# 2100 Queen Anne Avenue N

SDCI# 3034141-LU  
DESIGN RECOMMENDATION MEETING  
12/2/2020

1A - MASSING SCHEMES

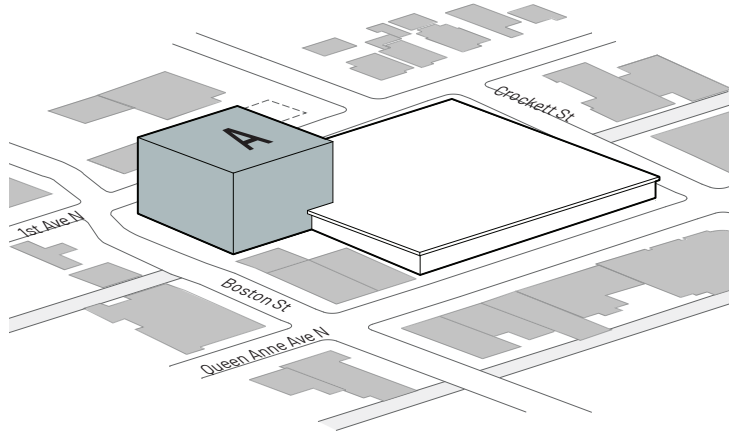
1a **Massing schemes** - The Board unanimously supported Option 3, finding the upper level setbacks and three-part massing scheme to be effective strategies for mitigating the height, bulk and scale of this large project.

2A - BUILDING B - STOOPS ALONG 1ST AVE - ACTIVE & ENGAGING STREETScape

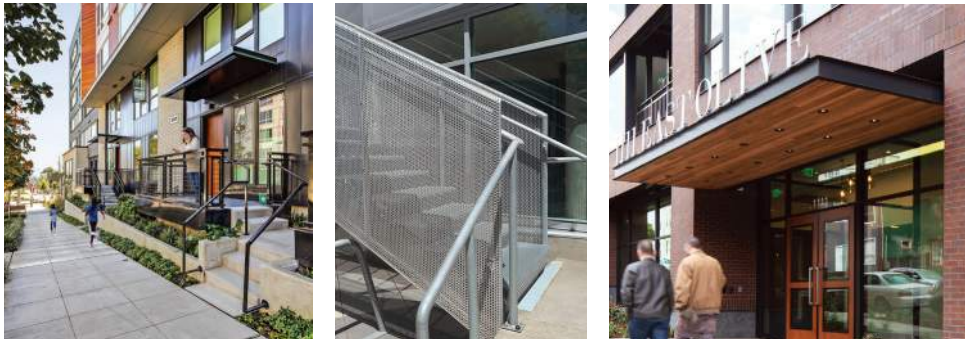
**2a Expression of massing break at street level** – The Board agreed that the central portion of 1st Avenue North (not shown in the packet) would be expected to meet the criteria identified for Crockett street, including the development of an active and engaging street scene and explorations of a street level expression of the upper level massing break. (CS2-II, DC4, CS3-1, PL3, CS3-II, DC2-I.ii)

The residential unit entries along 1st Avenue North have been developed further to respond to surrounding context by incorporating the stoop character of the single-family homes along 1st Avenue. A landscaped stair connection from the Level 2 courtyard to grade reinforces the break between Buildings A and B which provides an opportunity for residents to enter and exit the courtyard as they embark upon a walk and activate the activity on the sidewalk. The primary residential entry lobby is located at the corner of 1st and Boston, with the entry off Boston. There will be much activity visible within and increases transparency of the lobby providing a welcoming carved entryway to the building.

3B - CROCKETT ST MASSING BREAK EXPRESSION AT GRADE - COURTYARD STAIRS

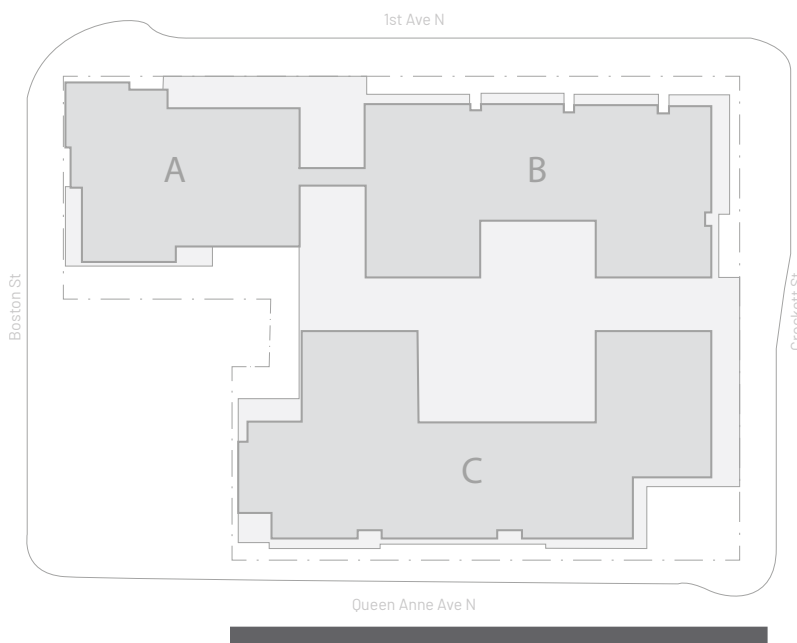
**Expression of massing break at street level** - The Board noted that the upper level massing break at this edge would seem to indicate a connection from the courtyard level to the street and as such presented a unique opportunity to clearly express the break in massing above the ground plane. The board asked the applicant to explore this possibility. (CS2-II, DC4, CS3-I, PL3, CS3-II, DC2-I.ii)

The courtyard stair has now shifted away from 1st Ave N to occur between Building B and C. This shift provided space to add an additional unit with a balcony, enhancing the residential character of this corner as requested by the neighborhood. The landscaped stair area has been enhanced by landscaping with a small open plaza providing a lush visual break for pedestrians with benches added for public sitting. At Building C, robust landscaping and transom glazing were added to provide both visual interest, and views into the deli prep area while simultaneously adding light into the deli seating area.

4B - MULTIPLE ENTRANCES ALONG THE QUEEN ANNE FRONTAGE

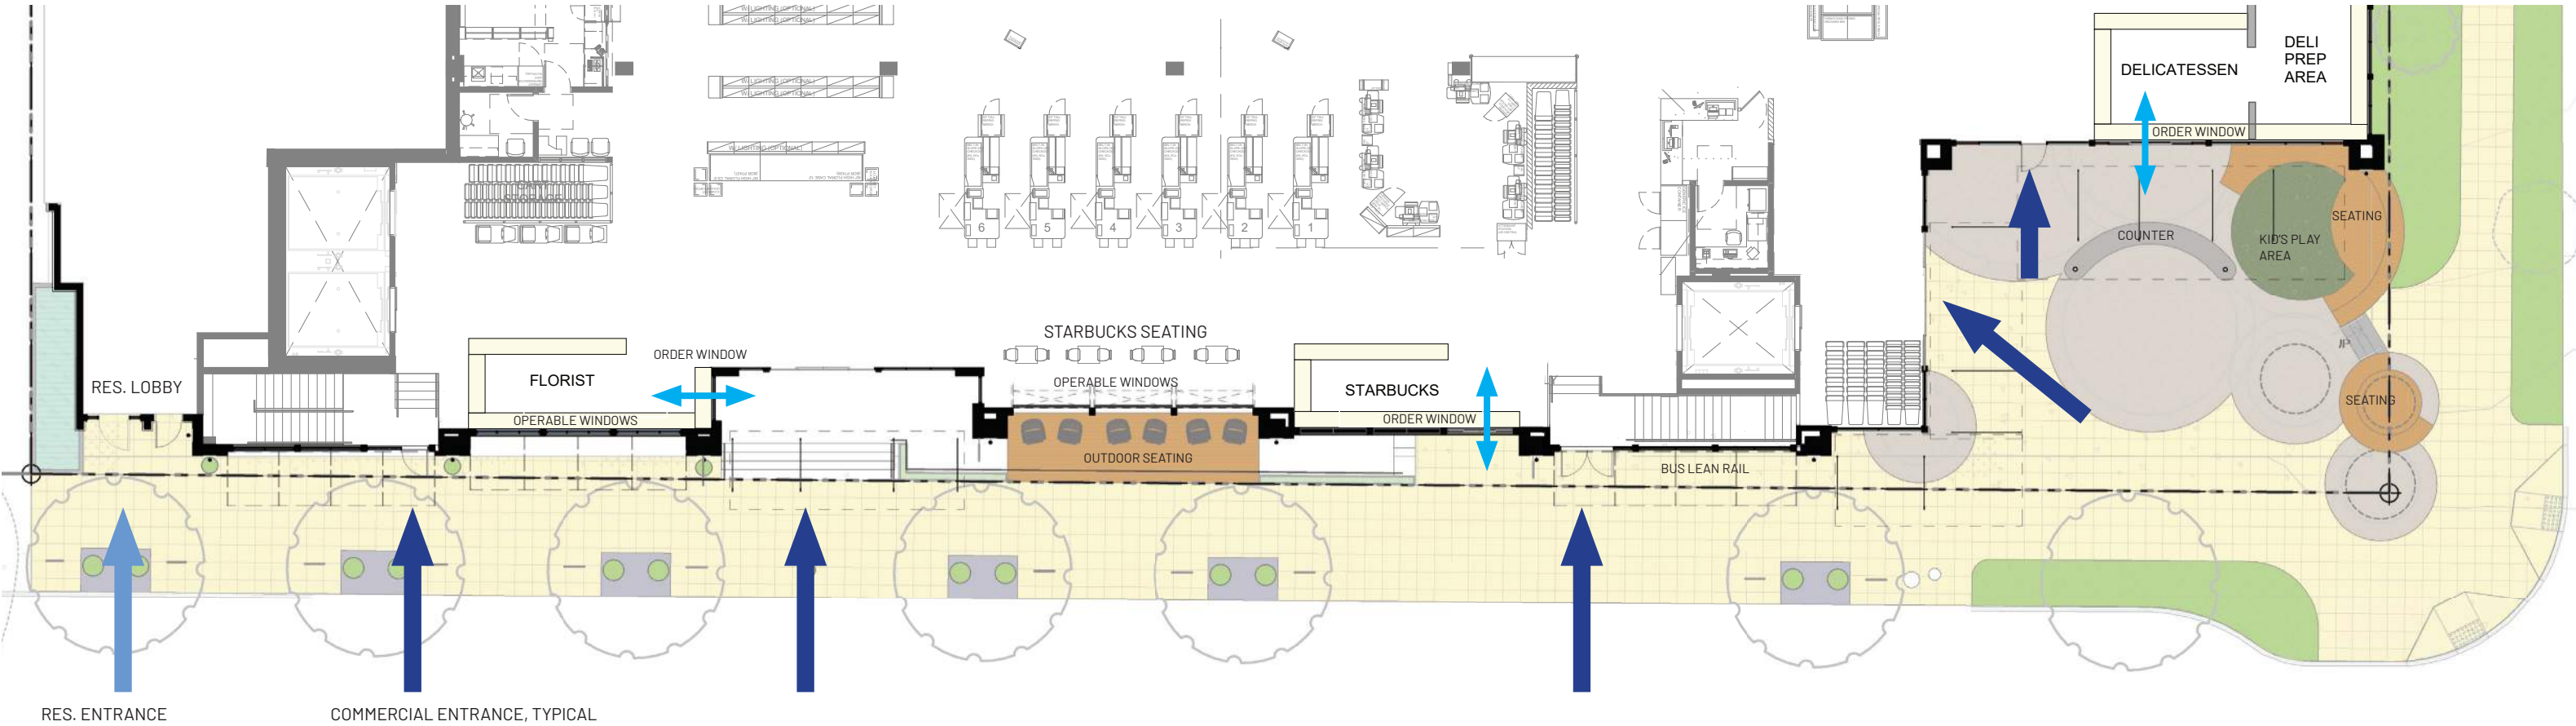
**4b Multiple entrances along the streetscape** - The Board agreed that a critical component in creating a vital urban environment that fosters human interaction was the porosity of the street edge. The board noted that extensive glazing could contribute to this but citing several unsuccessful recent examples, agreed that multiple additional entrances could likely be required along this extensive street front.

In response to community and EDG board comments, there are now 4 doors and 3 walk-up counters on the Queen Anne frontage to provide multiple opportunities for pedestrian and shopper interaction with the retail uses along the sidewalks.

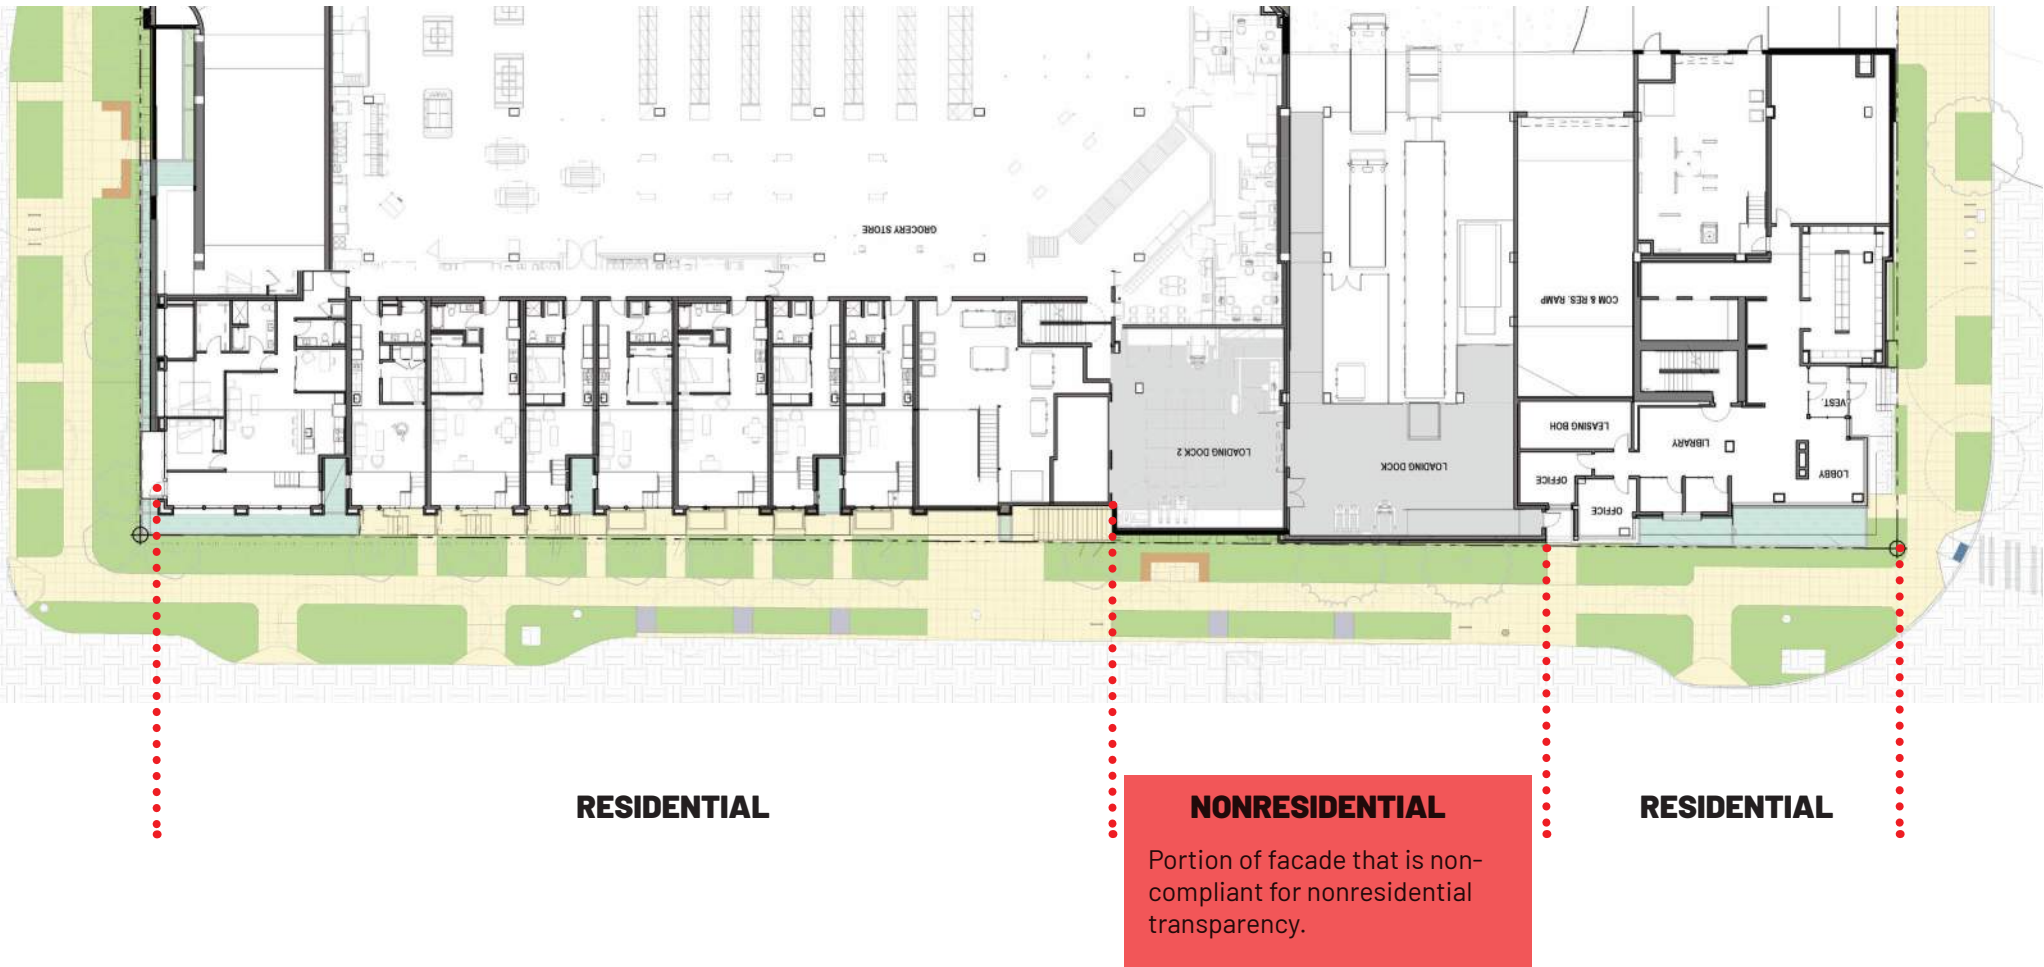
Request that the nonresidential portion of 1st Ave N provide 0% transparency.

The grocery store loading dock occupies 25% of the 1st Ave N facade. Glazing could be provided to comply with the code requirement, but the program is not ideal for transparency. Instead, a landscape mural representing the beauty of the northwest is proposed. The visually interesting mural and surrounding streetscape design (bench, sidewalk, landscape buffer) better meets the intent of the design guidelines to provide an enhanced pedestrian experience (CS3) and art in the pedestrian environment (DC3). The rest of the 1st Ave frontage (75% of total facade) will have units with stoops and a highly glazed lobby and leasing spaces, providing the activity (PL3) and human scale (DC2).

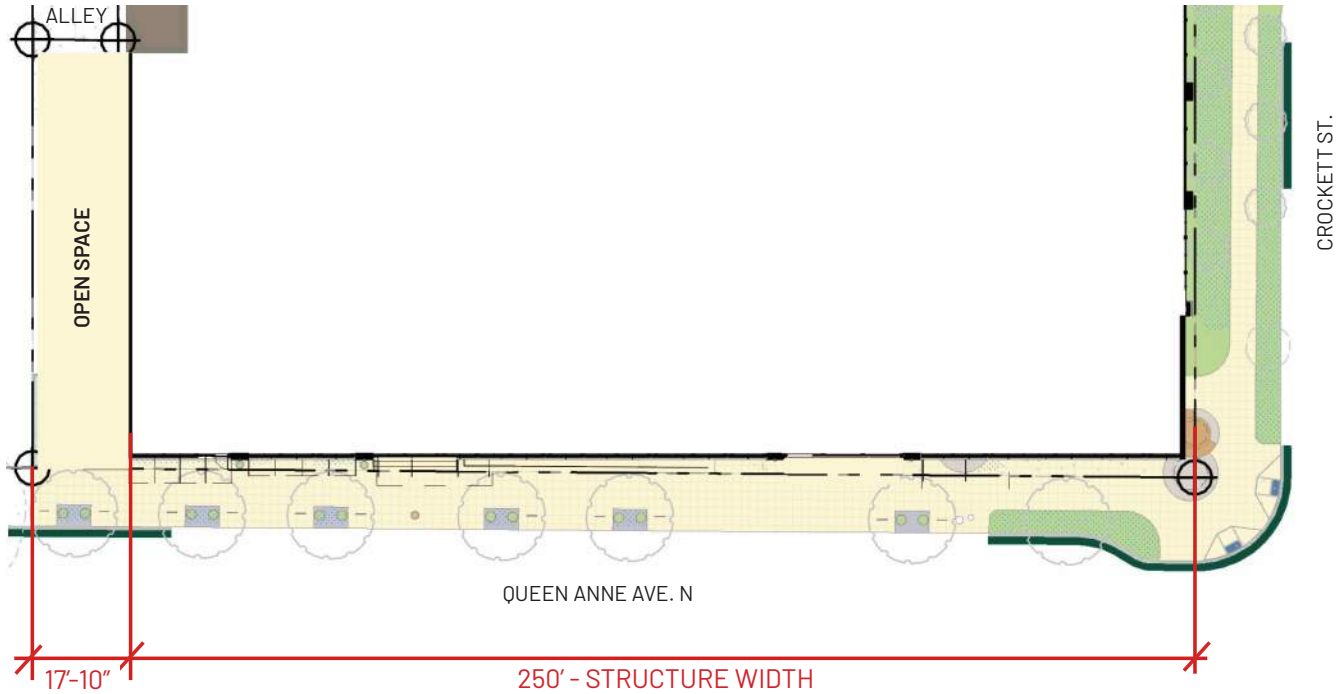
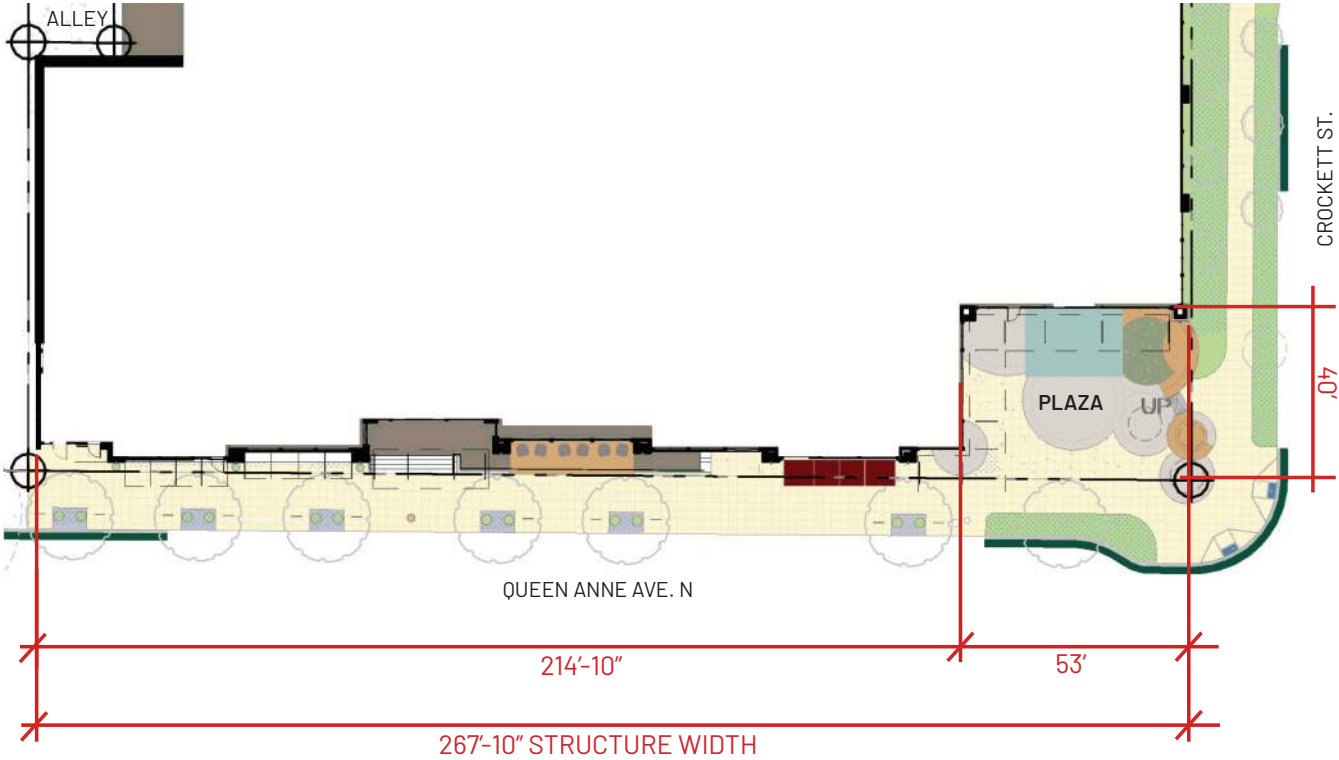
Propose the width of the building structure along Queen Anne Ave N to be +/-267'-10" along Queen Anne Ave N.

The design includes a +/-53' wide plaza at the corner of Queen Anne Ave N and Crockett that provides an opportunity for pedestrian interaction with seating and variety of spaces as well as a larger area for the bus stop. The plaza creates a break in the structure, thus reducing the linear footage along Queen Anne Ave N to +/-214'. The proposed plazas provide a better pedestrian and visual experience while still meeting the intent of the code. Additionally, the ground level facade is set back 5' along Queen Anne Ave N, providing more areas for seating and landscaping.

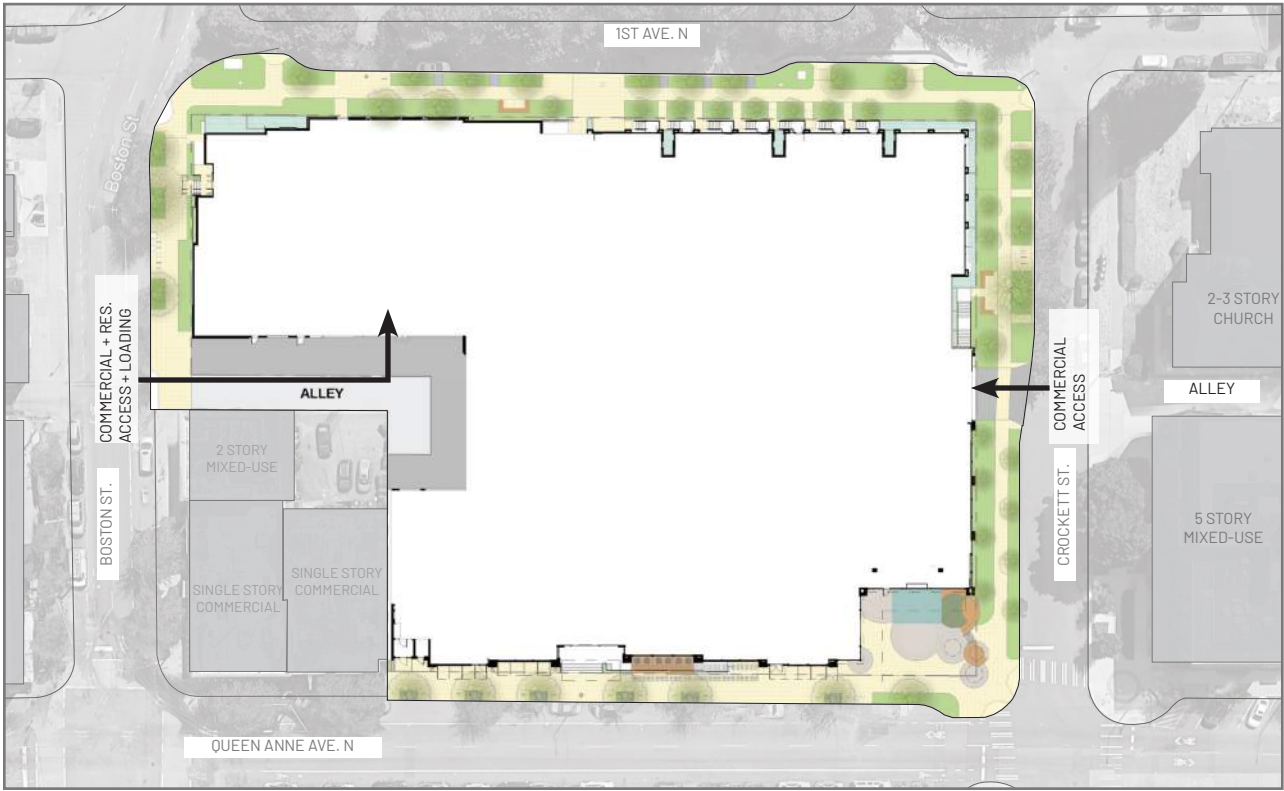
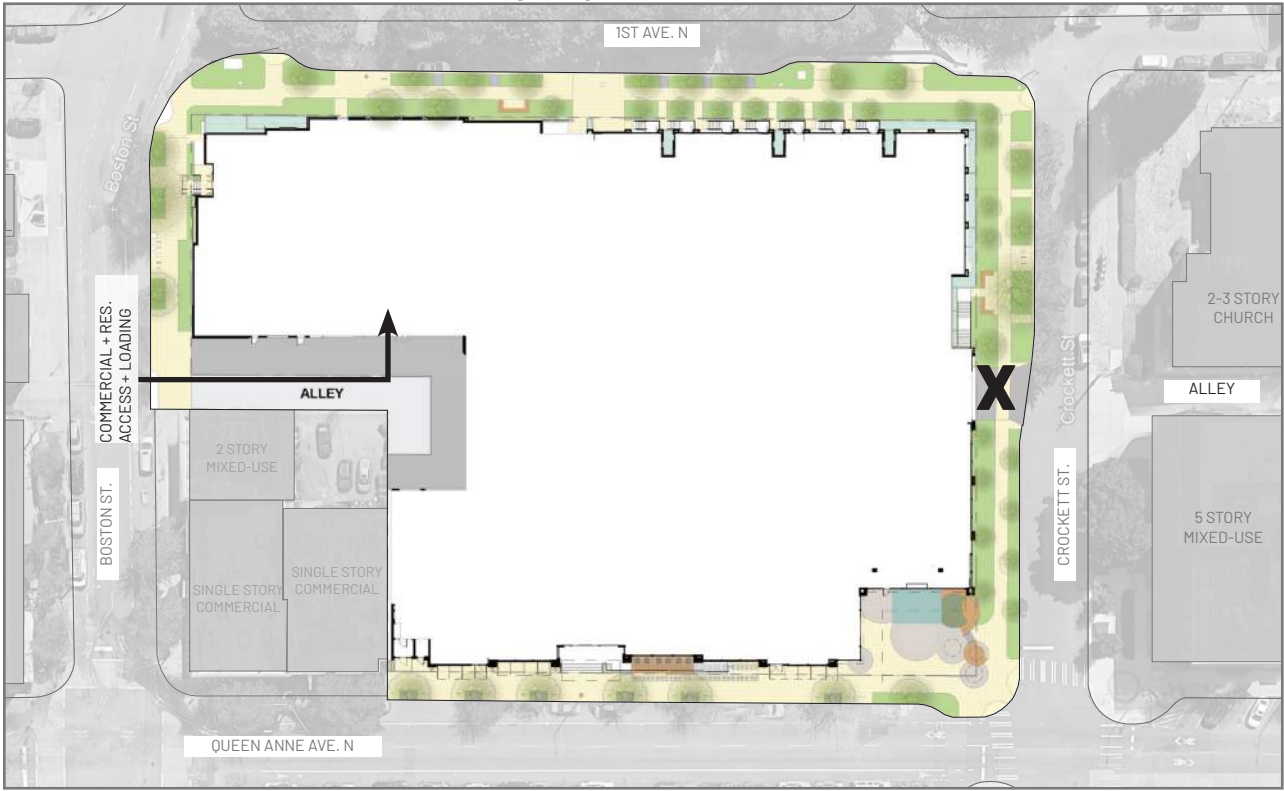
Request that access to parking occur at both Alley off Boston Street and Crockett Street.
